**RE: HISTORIC PRESERVATION COMMISSION APPLICATION NO. HPC2020-116
BLOCK 128, LOT 7 ALSO KNOWN AS 8 OCEAN PATHWAY**

Preliminary Review Notes

Amendment for HPC Application: 2020-116
8 Ocean Pathway,
Ocean Grove, NJ,07756

SITE PLAN

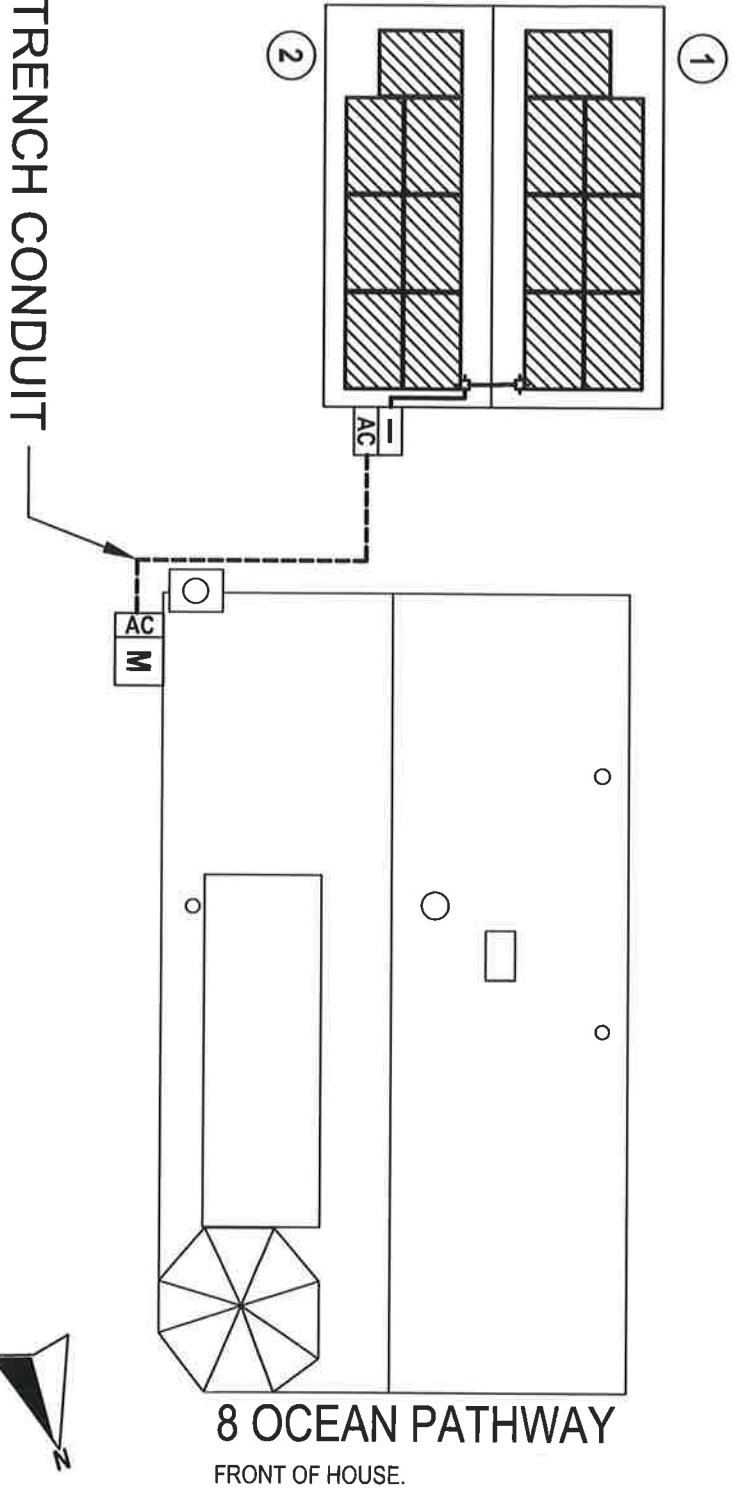
1. Solar panels that are visible to public view. Please review the following section of the current Design Guidelines and be prepared to discuss:
 - **Section IV, Subsection M**, of the *Ocean Grove Historic District Architectural Guidelines for Residential Structures*, p. 26-27: "Satellite dishes seriously detract from the characteristics of the District. Solar panels present a similar intrusion and usually constitute an even larger visual problem as do antenna towers. Property Owners of all residential buildings, whether undergoing repair, restoration, renovation, alteration, new construction or addition, or not, should (note): The placement of TV Satellite and all other visually offensive mechanical HVAC devices on roofs in a manner visible to public view is unacceptable."

A site visit is necessary to determine visibility. **Please be advised that for purposes of a thorough review during the site visit, you are asked to position at least one panel temporarily in its proposed location; this location should be the most prominent / most likely visible position.**

The following changes have been made to the above referenced application: Added 2 panels on the same roof section. Attached are the following documents: Zoning approval with the 2 additional panels, panel layout and design drawings. I hope this will suffice the requirements. Thank you.
